UNITED STATES ENVIRONMENTAL PROTECTION AGENCY

3589-87-I-EPA-01

We have reviewed the material you provided on the following interim response actions proposed for the Weldon Spring site:

1. Dismantling of Building 401
2. Dismantling of Building 409
3. Removal of PCB Transformers
4. Debris Consolidation

PROCESS FLOW CHART FOR DOE'S PROPOSED WASTEWATER TREATMENT AT THE WELDON SPRING SITE

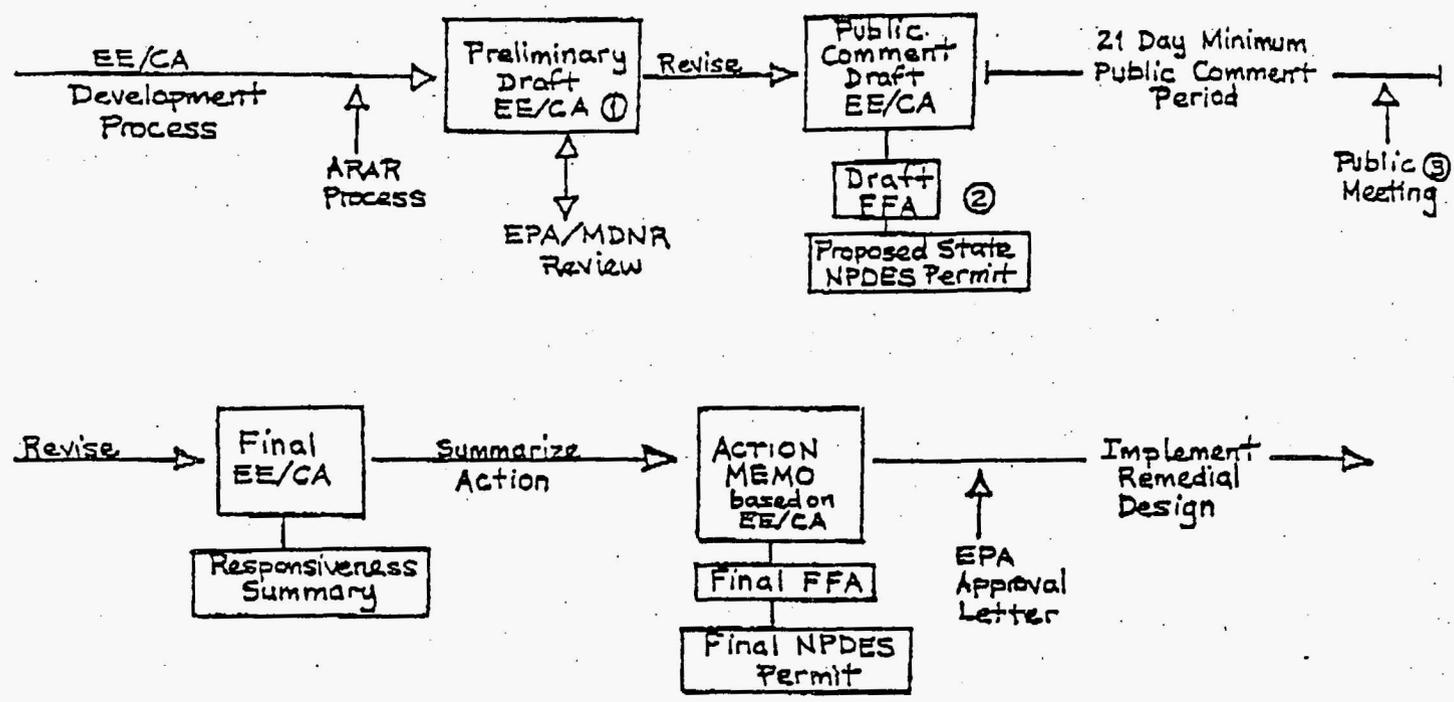
1. Effluent limits are proposed by DOE based on BAT and/or ARARs.
2. It would be desirable to make the FFA and NPDES permit (if necessary) available for public comment along with the EE/CA.
3. Timing of the public meeting can vary, however it is desirable to hold it after the EE/CA is made available for public comment so that it provides an opportunity for oral comment.
